RENESAS TECHNICAL UPDATE

Product Category	MPU/MCU		Document No.	TN-RL*-A069A/E	Rev.	1.00
Title	Restriction regarding Watchdog timer		Information Category	Technical Notification		
Applicable Product	RL78/G11, RL78/G12, RL78/G13, RL78/G14, RL78/G1A, RL78/G1C, RL78/G1D, RL78/G1E, RL78/G1F, RL78/G1G, RL78/G1H, RL78/L12, RL78/L13, RL78/L1A, RL78/L1C, RL78/I1A, RL78/I1B, RL78/I1C, RL78/I1D, RL78/I1E	Lot No.	Reference Document	Latest user's Manual of applicable products

Figure 1. Flowchart for judging applicable if your software is affected

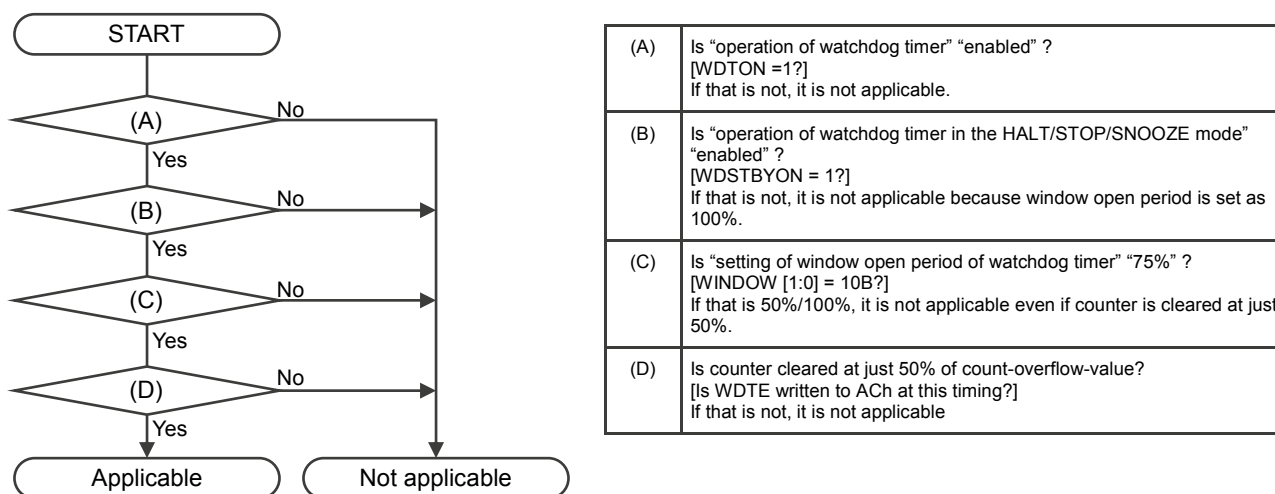
Wrong WDT-RESET may assert when WDT counter is cleared (writing ACh to WDTE register) at just 50% of count-overflow-value and when window open period of watchdog timer is set to 75%.

When all of following conditions is established, the restriction applies.

- (1) "Operation of watchdog timer" is "enabled" (WDTON = "1")
- (2) "Operation of watchdog timer in the HALT or STOP mode" is "enabled" (WDSTBYON = "1")
- (3) "Setting of window open period of watchdog timer" is "75%" (WINDOW1, WINDOW0 = "10b")
- (4) During watchdog timer operates, counter is cleared at just 50% of count-overflow-value (writing WDTE register to ACh).

- 1) Set "window open period" to "50%" or "100%".
Set bit 6 and bit 5 in user option byte (000C0h) to 01b (50%) or 11b (100%)
- 2) If "window open period" is set to "75%" (WINDOW1, WINDOW0 = "10b"), please perform Counter- clear within the period except for just 50%.
